Accessibility Design Review Report

Project Title: **Compass 2 Warehouse and Distribution Centre
Lot 1 Eastern Creek Drive, Eastern Creek**

Job Number: **21497**

Report Version: **21497_ADR_SSDA_v1.2**

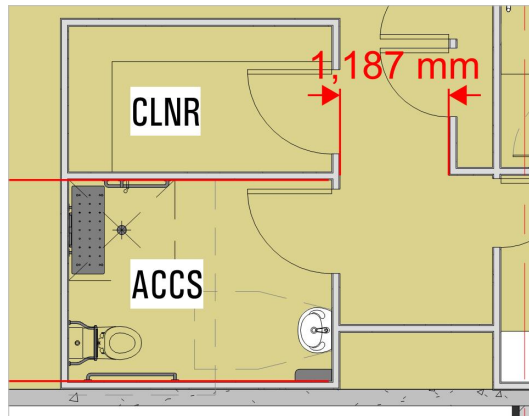
Minimum 1220mm circulation space for a predominantly side-on approach is required to the external side of the first-floor accessible unisex sanitary facility doorway.

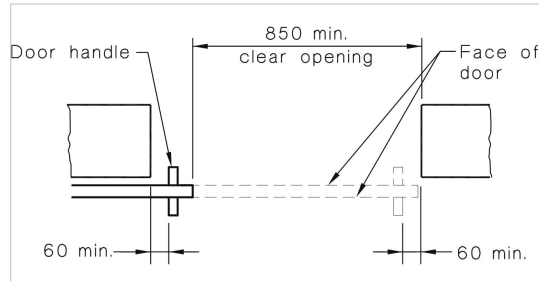
Ensure hardware circulation space of 60mm either side is provided to sliding doorways in the open/closed position. This generally requires an active leaf cavity/clearance of 1000mm.

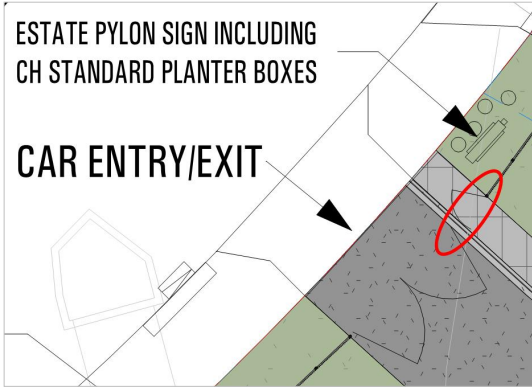
It is assumed pedestrian access will not be provided from Honeycomb Drive.

Accessible parking is proposed adjacent the office building entry. Kerb/step ramps appears to be proposed as the parking is not on the same grade as the footpath.

Compliant access (whether internally or externally) to the Dock Office may be required depending on further investigation of use/user groups

Access appears to be proposed through the Principal Pedestrian Entry of the office building.

Further details will need to be provided for review at a more detailed design stage regarding access through pedestrian entries to the warehouse & Dock Office etc...

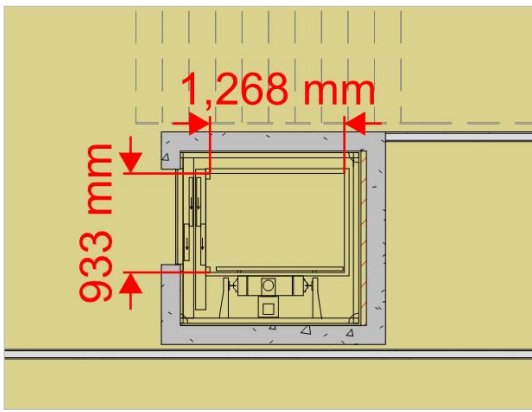
There are currently no passenger lifts proposed as none are technically required. The following is provided if they are required for further design development.

DtS Provision	Comment(s)/Recommendation(s)	Status
<p>Every passenger lift must –</p> <ul style="list-style-type: none"> • be one of the types identified in Table E3.6a, subject to the limitations on use specified in the Table; and • have accessible features in accordance with Table E3.6b; and • not rely on a constant pressure device for its operation if the lift car is fully enclosed. 	<p><u>Design Detail:</u></p> <p>The Passenger lift indicated within the Office scales a floor space of 930mm x 1270mm in lieu of 1100mm x 1400mm (vertical travel <12m).</p> 	DD

<p><u>Design Detail:</u></p> <p>The Dock Office may require the same size passenger lift as above. Refer to D3.1 & D3.4 for further information.</p> <p>Proposed passenger lifts shall have the following features –</p> <ul style="list-style-type: none"> • Handrail complying with the mandatory handrail provisions of AS1735.12, • Lift floor dimensions not less than 1,100mm x 1,400mm where the lift vertical travel is less than 12m, • Lift floor dimensions not less than 1,400mm x 1,600mm where the lift vertical travel is more than 12m, • Minimum clear door opening complying with AS1735.12, • Passenger protection system complying with AS1735.12, • Lift landing doors at the upper landing, • Lift car and landing control buttons complying with AS1735.12, • Lighting in accordance with AS1735.12, • Automatic audible/visual information within the lift car and at the landings as prescribed, • Emergency hands-free communication, including a button that alerts a call centre of a problem and a light to signal that the call has been received. <p>A design compliance certificate should be obtained from the lift designer to confirm compliance with the relevant provisions of the BCA and Australian Standards.</p>

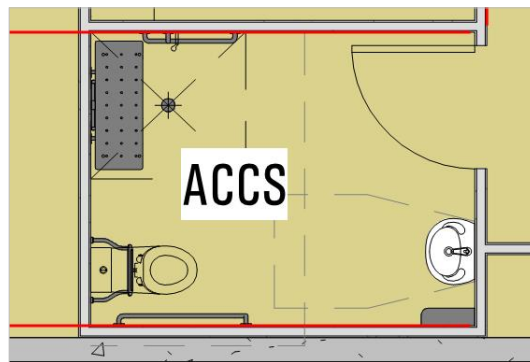
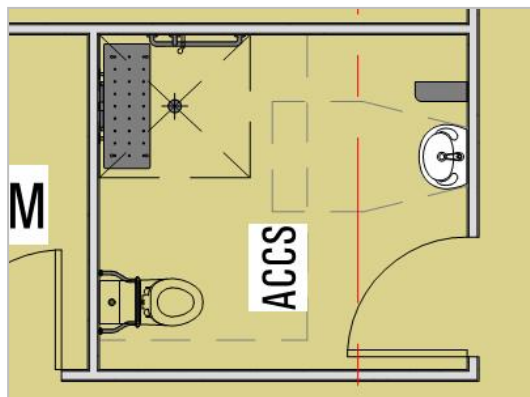
An accessible unisex sanitary compartment is proposed on each level of the main office building to satisfy the above requirement.

The orientation of the pan within the accessible unisex sanitary compartments should alternate to allow for left- and right-hand transfer. Plans currently indicate 2x RH transfers.

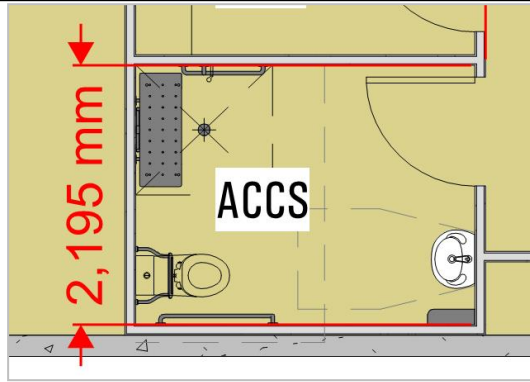
The office first floor accessible compartment scales 2195mm wide in lieu of a minimum 2300mm for the proposed configuration.

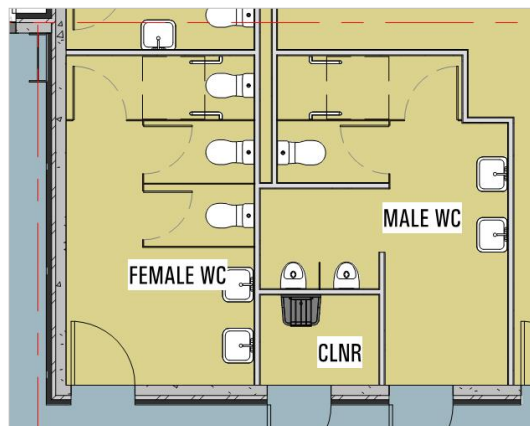
An accessible unisex sanitary compartment may be required in association with the Dock Office bank of toilets. Refer to D3.1 & D3.4 comments for further information.
